**Water Resources Department**

## FINAL ORDER

# Special Standards Request Form

- (7) Diagram showing the pertinent features of the proposed well design and construction: (attach additional pages if needed)

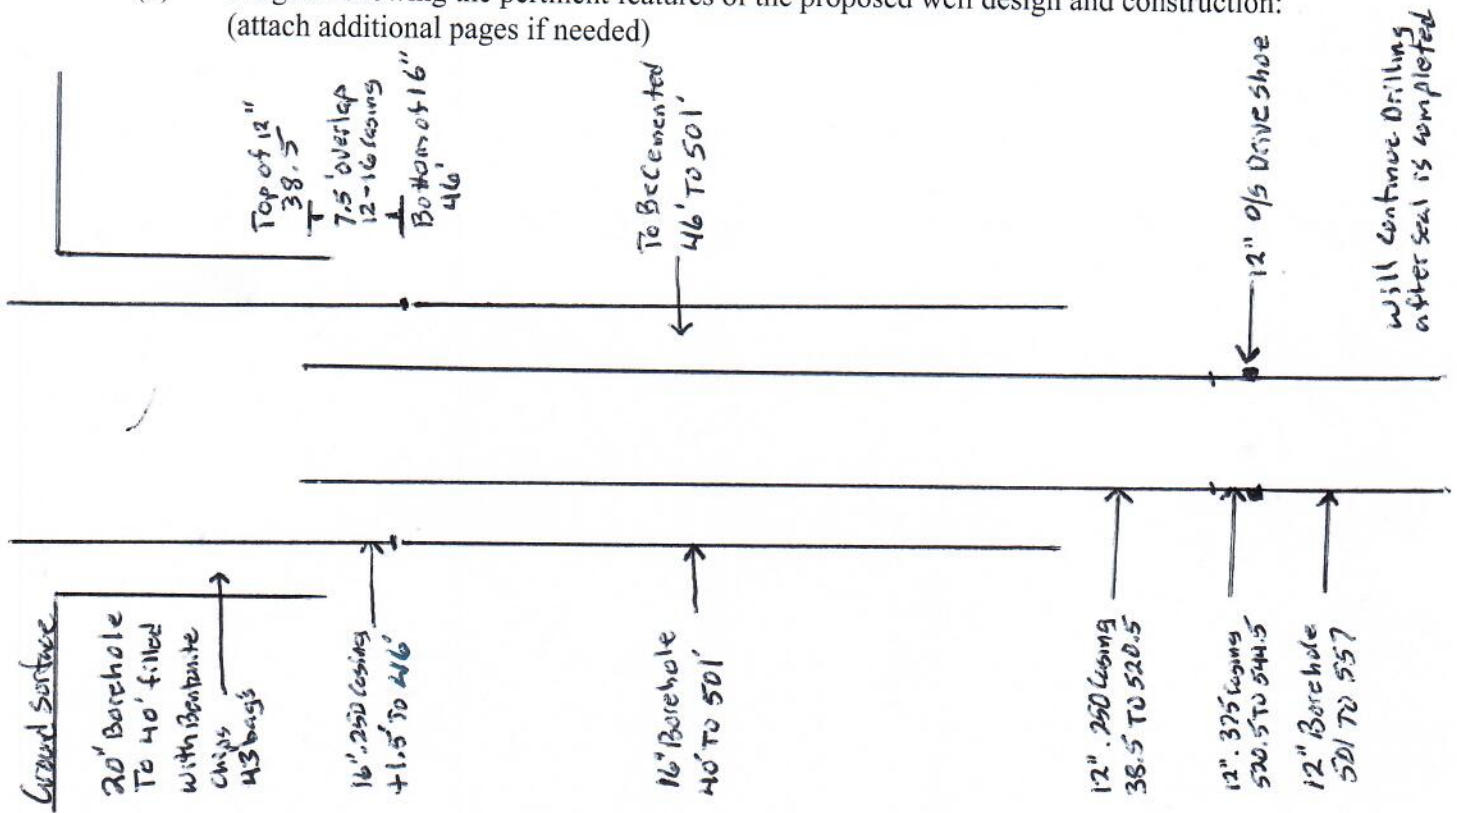
(5) The unusual site conditions which necessitate this request: 12" Casing has dropped in  
well and can not be retrieved back to the surface. Right now 16" .250 casing is sealed in +1.5 to 46'.  
12" casing is -38.5 to 520.5 .375 casing is 520.5 to 544.5

(6) The proposed construction methods that the bonded well constructor believes will be adequate for this well: (attach additional pages if needed)  
We believe the 20.5' of 12" .250 casing below 500' is not a big concern.  
We are proposing cementing 12" casing in place as it is now. Overlap between the 12" and 16" would only be 7.5';  
however, it would be cemented from that point to approx 501' and 16' casing is already sealed to 40'.

The Special Standards Request Form you submitted for owner: Otis Creek Ranch, Start Card number: 1053711, is hereby approved for the following: You may construct this well as described on your Special Standards Request Form dated September 21, 2021. All other well construction standards must be met. A copy of your Special Standards Request Form is enclosed.
